# Final Environmental Impact Statement for the Buckman Water Diversion Project

# Final Environmental Impact Statement for the Buckman Water Diversion Project

**Lead Agencies:** USDA Forest Service and  
USDOI Bureau of Land Management

**Title and Location of Proposed Action:** Buckman Water Diversion Project,  
located in Santa Fe County, NM

Figure 2. Vicinity map.

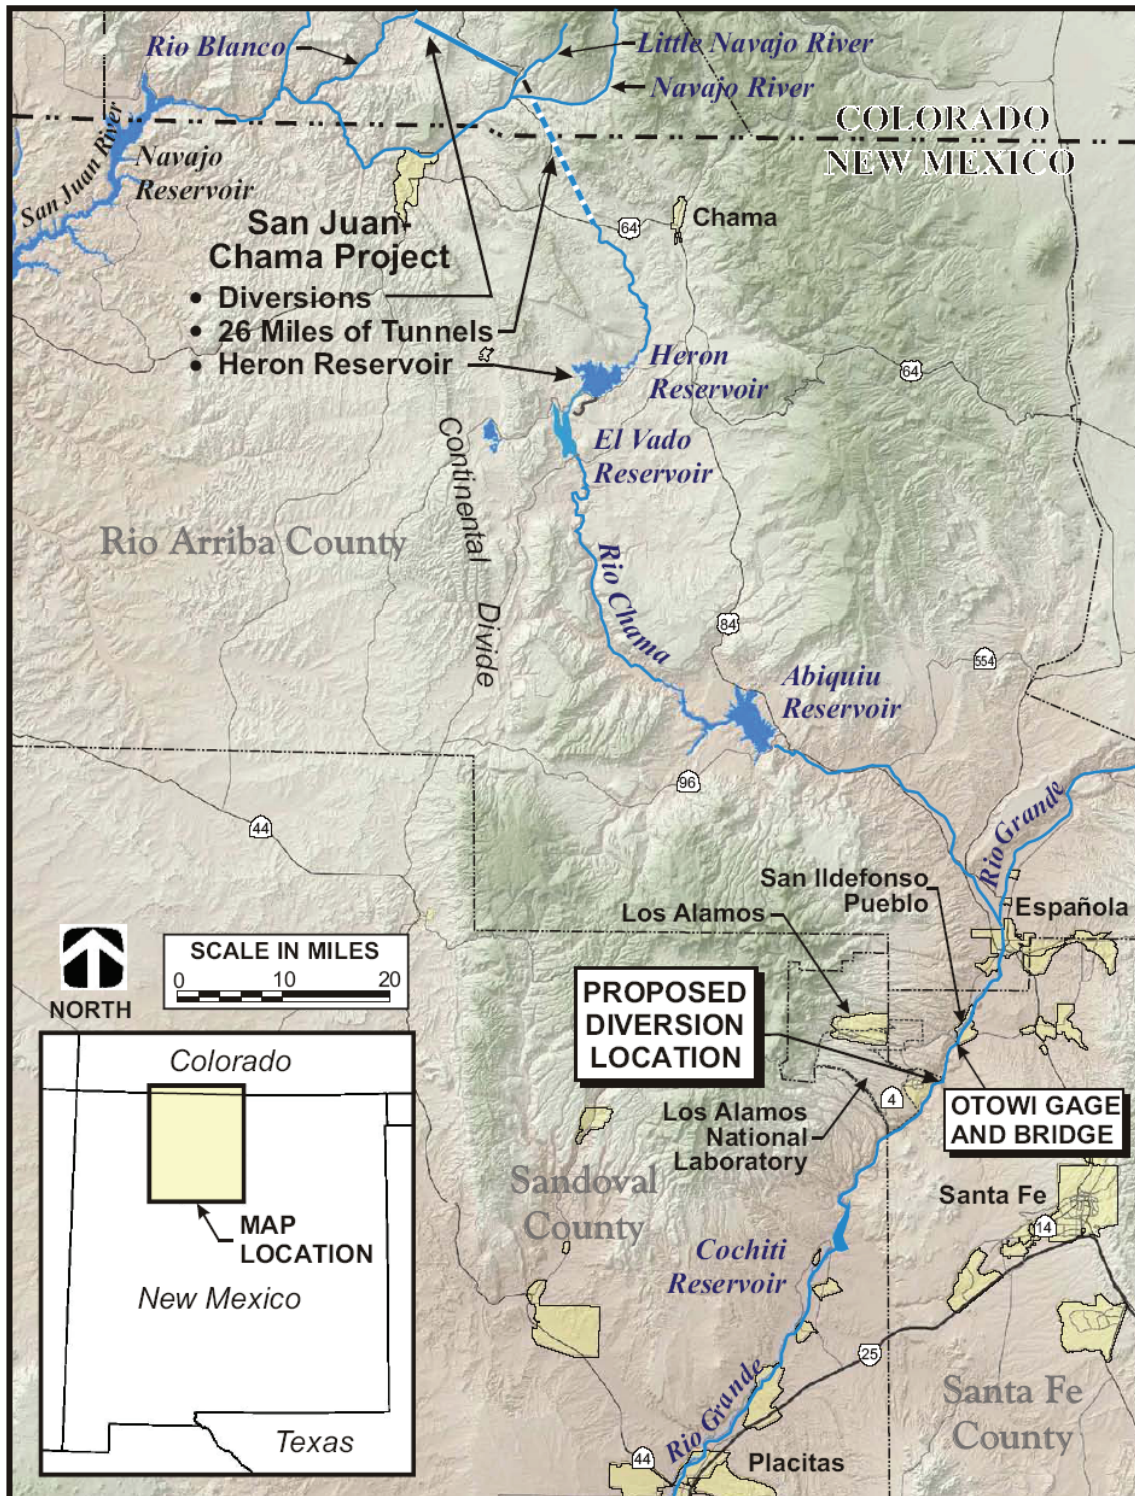
8. At the scoping meeting and on the October 16, 2002 tour, we expressed our concern that LANL is not represented on the maps about the proposal. In fact, we were surprised to see on Figure 2 that the label “Proposed Diversion Location” covers the LANL site. p. 18 draft EIS. } **5-12**

- 5-11 Comment noted.
- 5-12 The location of Los Alamos National Laboratory has been added to Figure 1 (Draft EIS, page 8). In addition, Los Alamos National Laboratory has been added to Figure 2 (Draft EIS, page 18).

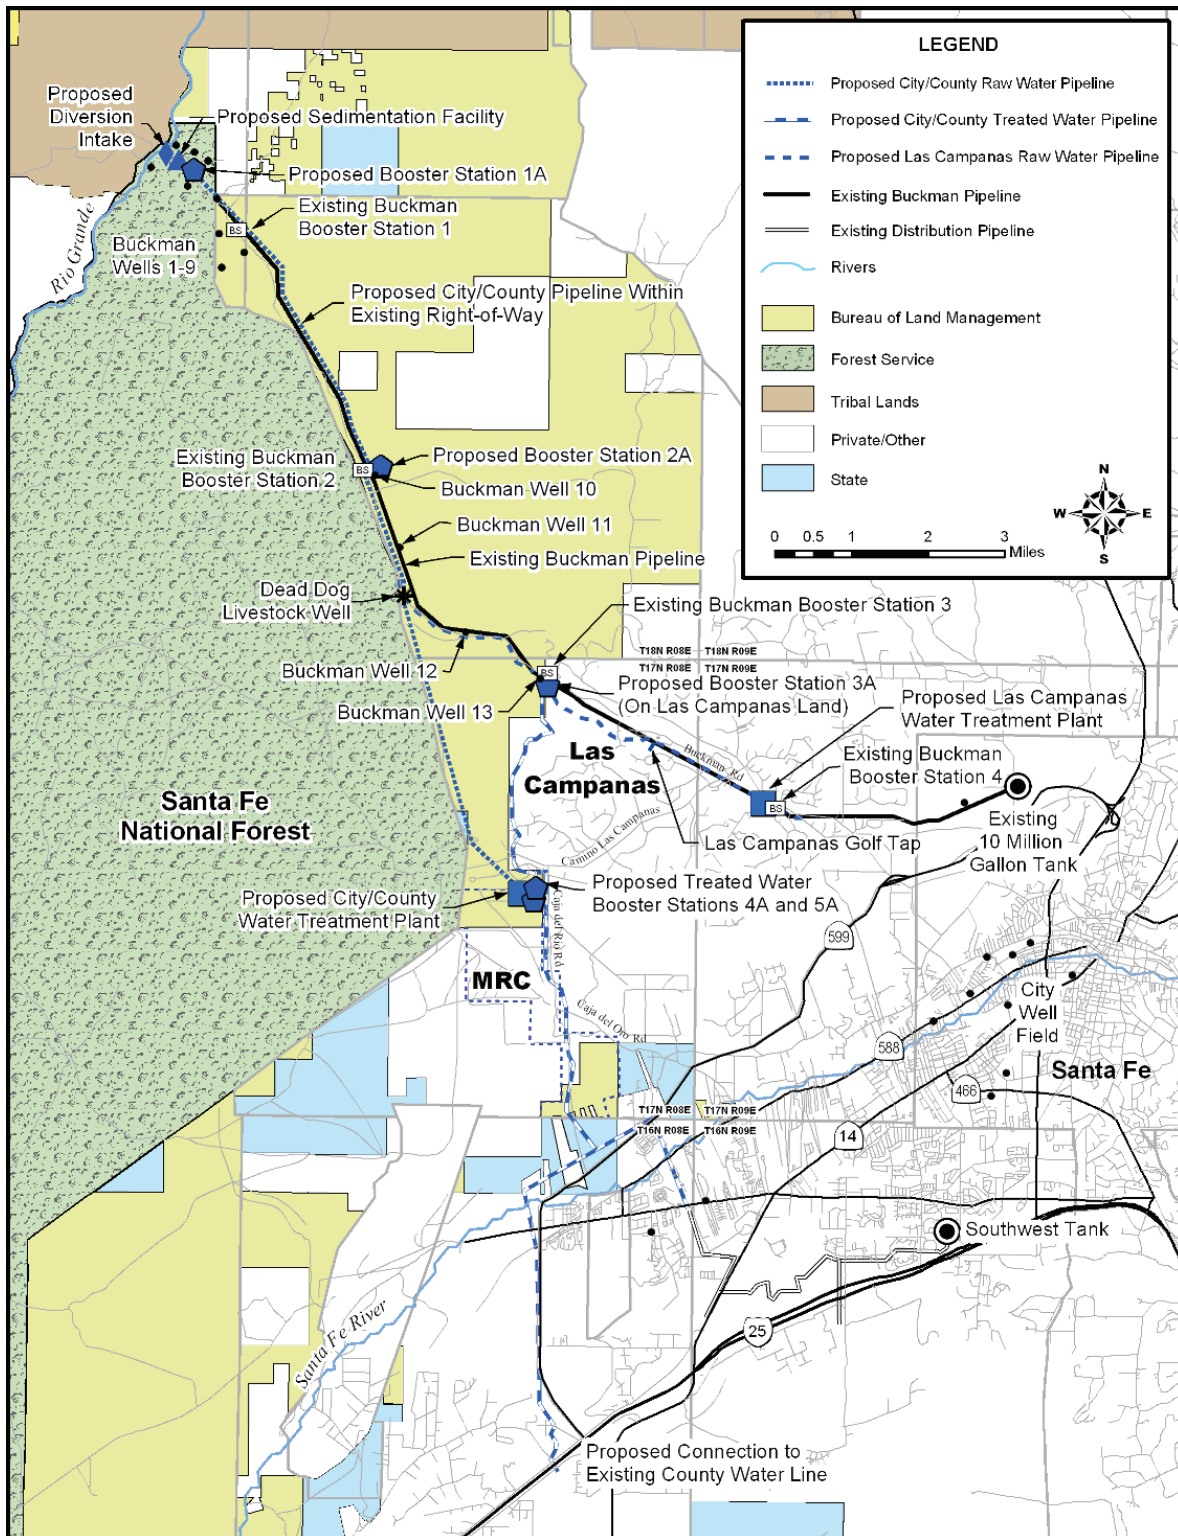
16. We note in Figure 3 that the proposed City/County Treatment Water Pipeline terminates a little south of I-25. The final EIS should explain what it planned for that terminus. p. 20 draft EIS. } **5-21**

- 5-21 The text in Figure 3 on page 20 of the Draft EIS shows termination of the proposed City/County treated water pipeline as the proposed connection to the existing County water line. No additional changes will be required for the Final EIS.

Figure 18. Treated Water Pipeline Alternatives.

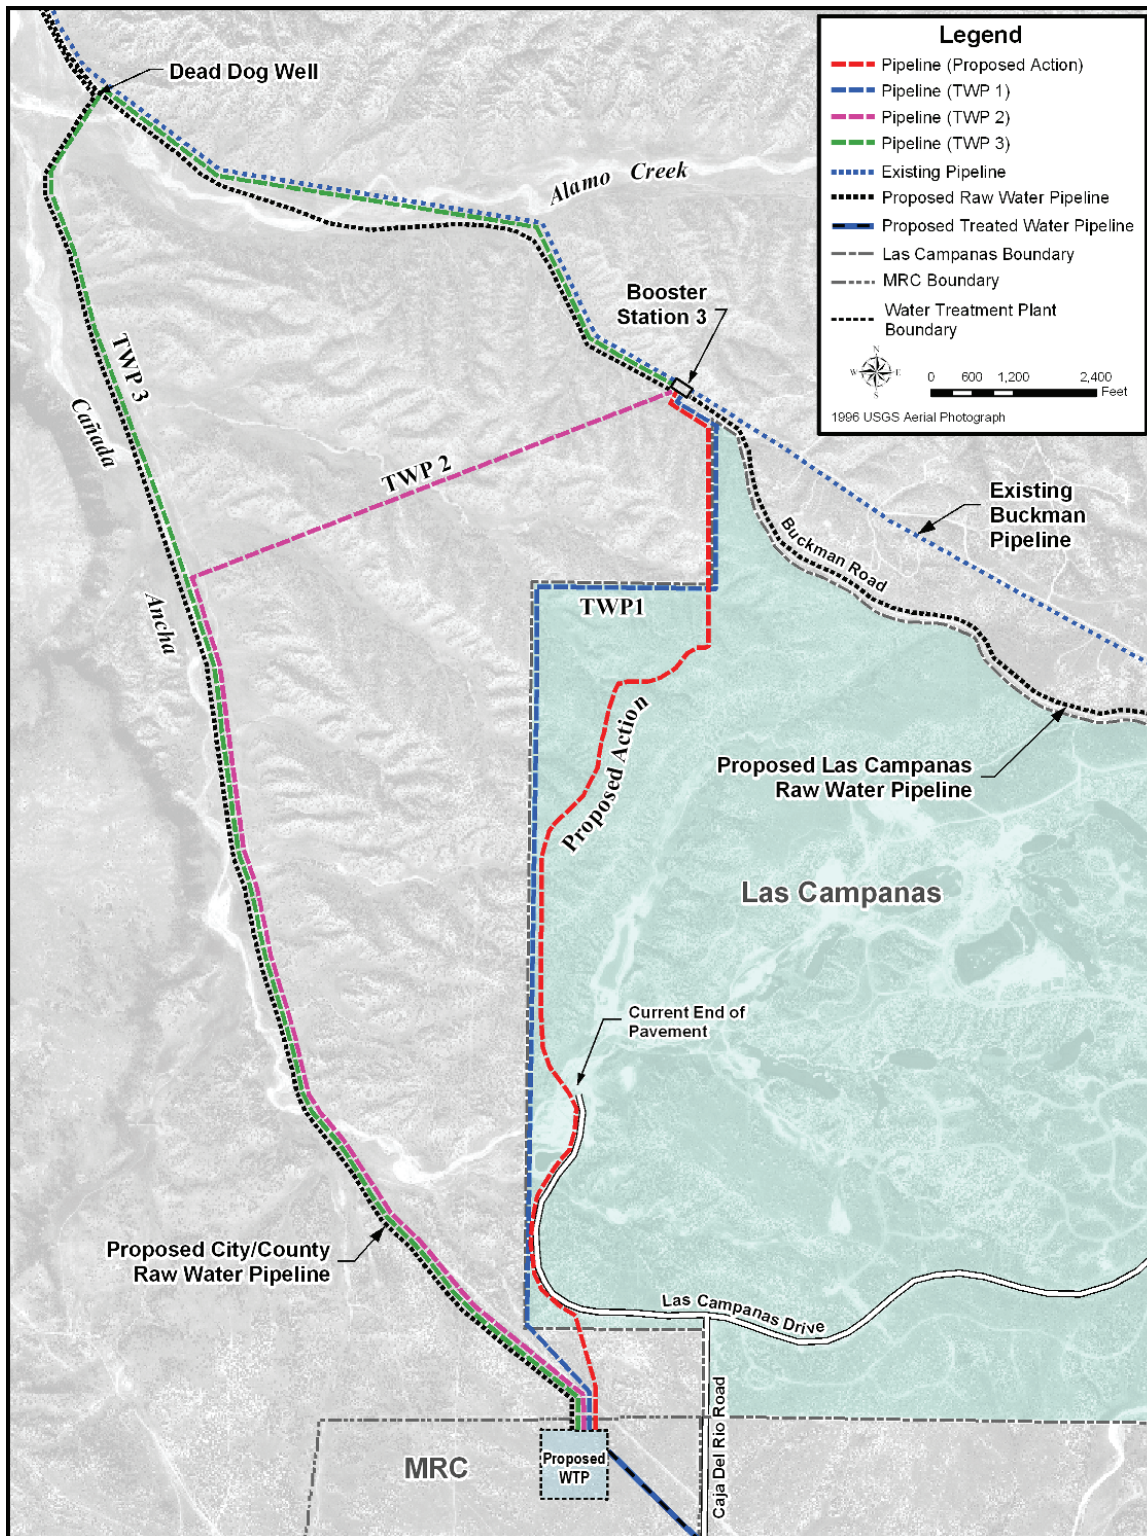
29. We were unable to distinguish the alternatives for the Treated Water Pipeline Alternatives in Figure 18 because the figure was printed in black and white. p. 57 draft EIS. We were also unable to distinguish the alternatives for the power upgrade facilities for the proposed action and	} <b>5-34</b>

- 5-34 Figures 18, Treated Water Pipeline Alternatives and Figure 19, Location of Power Upgrade Facilities for Proposed Action and Alternative AGP1 will be printed in color in the Final EIS.

Figure 19. Location of power upgrade facilities for Proposed Action and Alternative AGP1.

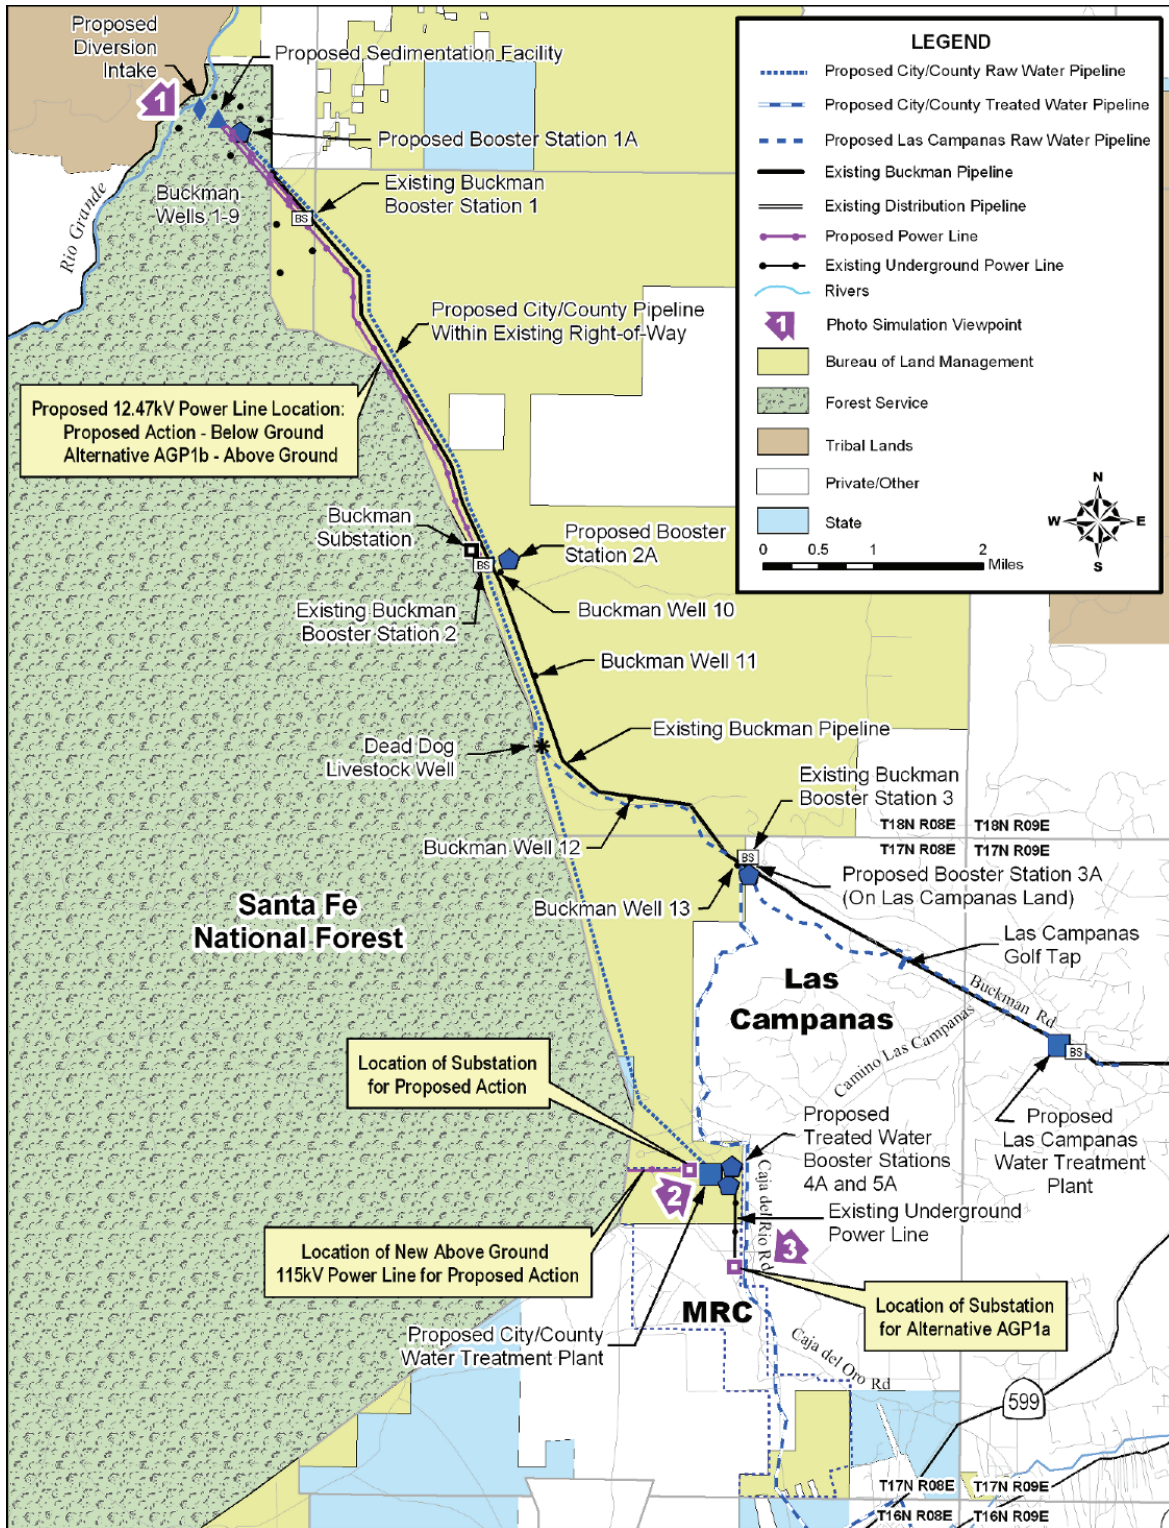
- alternative AGP1 in Figure 19 because it was printed in black and white. p. 60 draft EIS. We strongly urge the FS and BLM to print these figures in color in the final EIS. } **5-34  
Cont.**
